HISTORIC AND DESIGN REVIEW COMMISSION

HDRC CASE NO: 2022-313
ADDRESS: 2033 W GRAMERCY PLACE
LEGAL DESCRIPTION: NCB 1932 BLK 39 LOT 9
ZONING: R-6, H
CITY COUNCIL DIST.: 7
DISTRICT: Monticello Park Historic District
APPLICANT: Lucia Martinez/MARTINEZ LUCIA HERNANDEZ & MARTINEZ ROBERT R
OWNER: Lucia Martinez/MARTINEZ LUCIA HERNANDEZ & MARTINEZ ROBERT R
TYPE OF WORK: Driveway modifications, rear concrete patio
APPLICATION RECEIVED: May 14, 2022
60-DAY REVIEW: Not applicable due to City Council Emergency Orders
CASE MANAGER: Hannah Leighner

The applicant is requesting a Certificate of Appropriateness for approval to:

1. Replace the existing ribbon driveway with a poured concrete driveway.
2. Pour a 15 square foot concrete pad in the rear yard.

2033 W. Gramercy

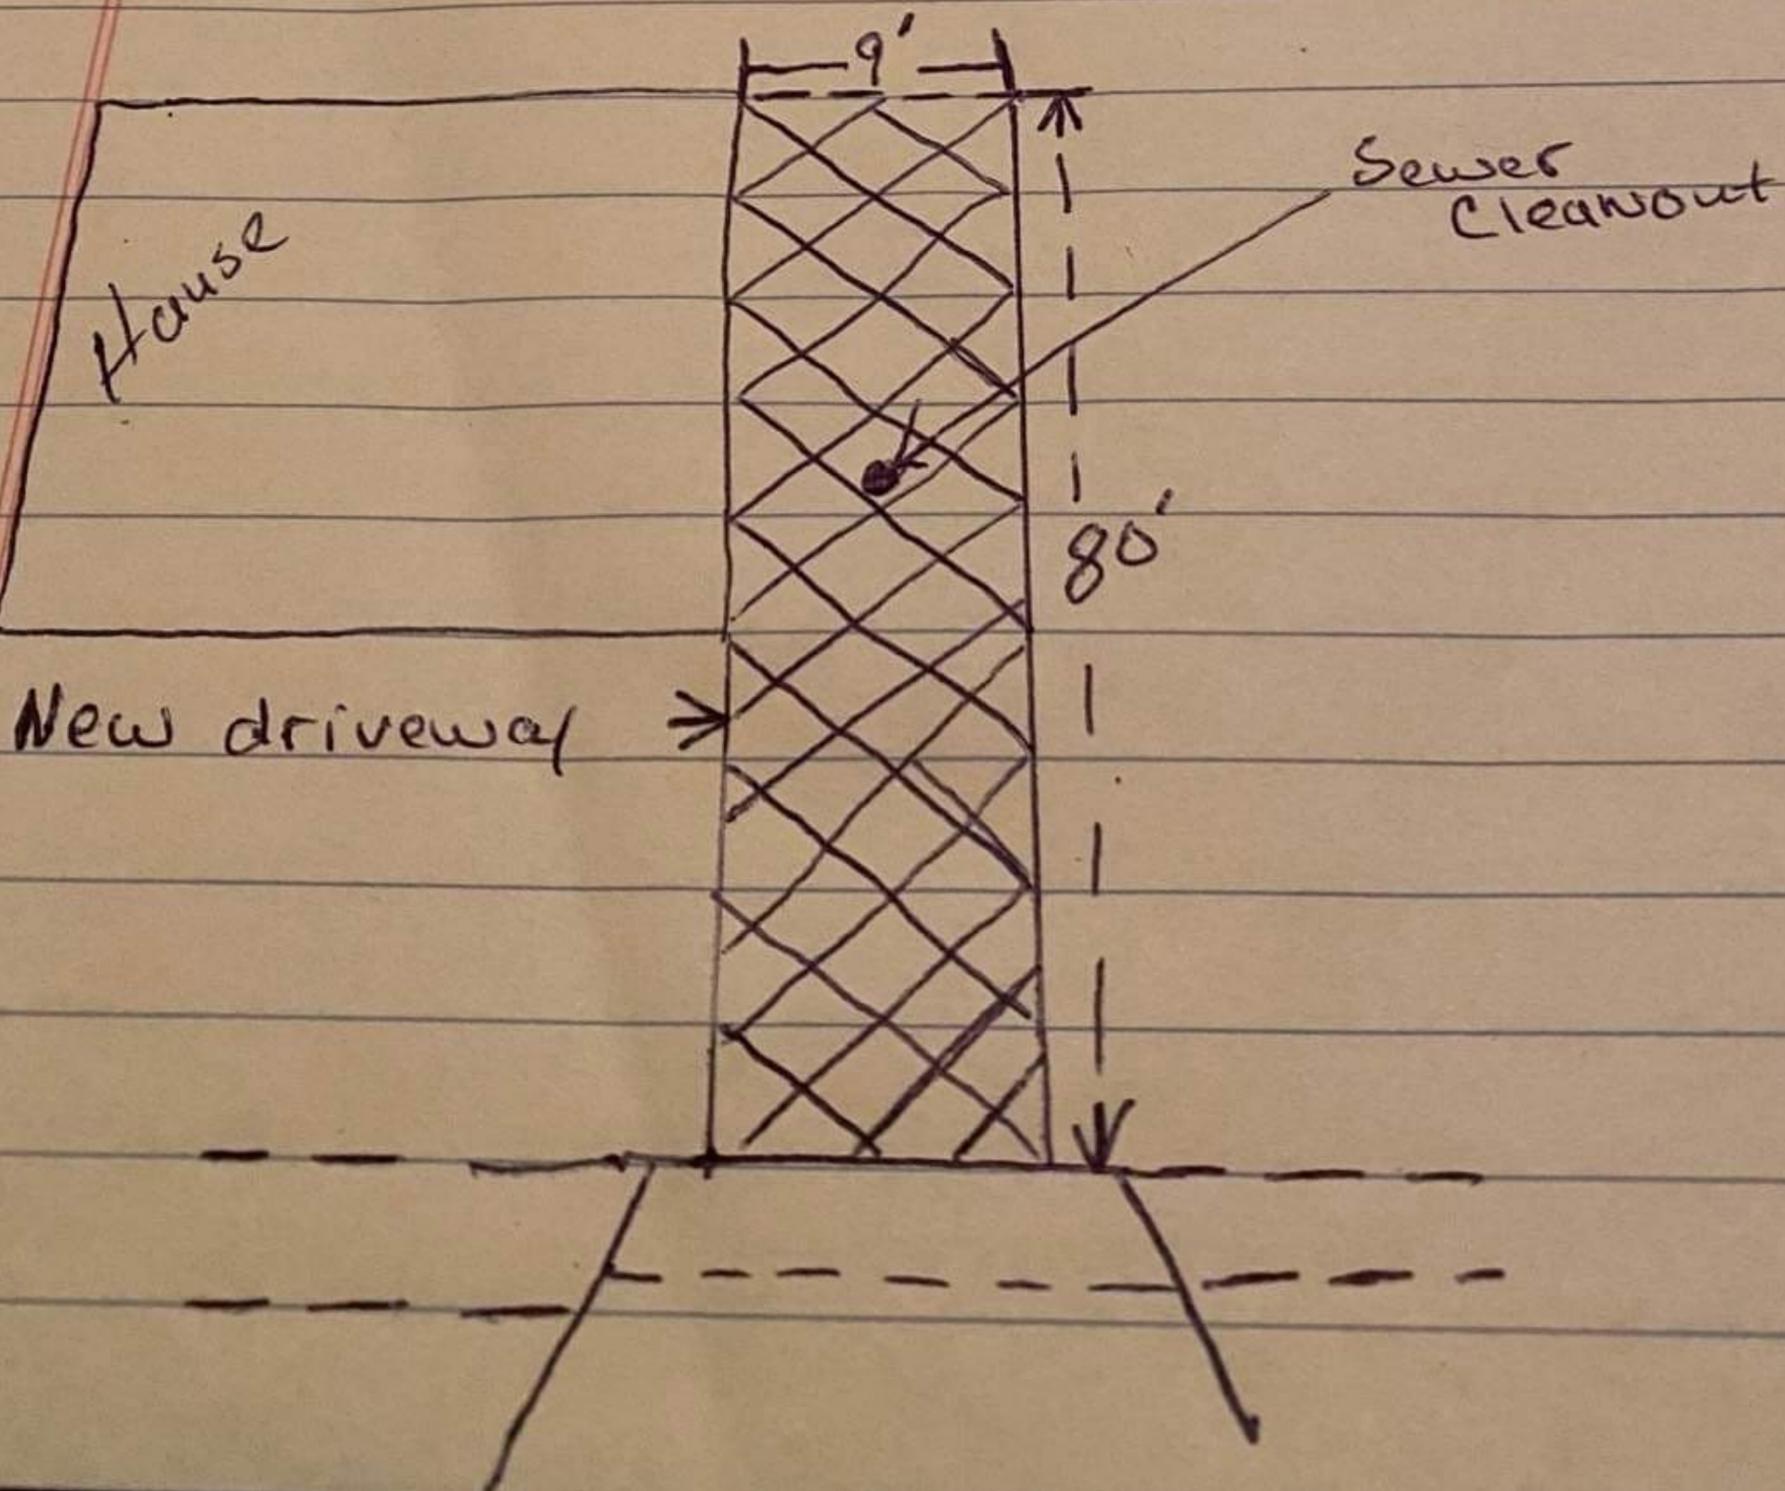
- b. DRIVEWAY MODIFICATION – the applicant is requesting to replace the existing, degraded, concrete ribbon driveway with a solid, poured concrete driveway. Historic Design Guideline 5..B.i for Site Elements advises to retain and repair in place historic driveway configurations, such as ribbon drives, and to incorporate a similar driveway configuration—materials, width, and design—to that historically found on the site. Historic driveways are typically no wider than 10 feet. Staff does not find the request to be consistent with this guideline. Repair and maintenance of the existing ribbon driveway, to match the original material, width, and design, would be appropriate.

- c. HARDSCAPING INSTALLATION – The applicant is requesting to install a 15-foot by 15-foot concrete pad at the rear of the house. The Historic Design Guidelines for Site Elements 3.B.ii states that new hardscaping should be limited to areas that are not highly visible, and should not be used as wholesale replacement for plantings, and that, if used, small plantings should be incorporated into the design. Staff finds that the placement and footprint of the poured patio are appropriate.

1. Staff does not recommend approval of item 1, replacement of the existing driveway with a poured concrete driveway, based on finding b. Staff recommends that the existing driveway be repaired in-kind to match the original in material, width, profile, and design. Installation of pavers between repaired ribbons may be appropriate; the applicant is required to submit material specifications to staff if this modification is requested.
2. Staff recommends approval of item 2, installation of a concrete patio at the rear of the house, based on finding c, with the stipulation that the applicant incorporate landscaping around the concrete slab.
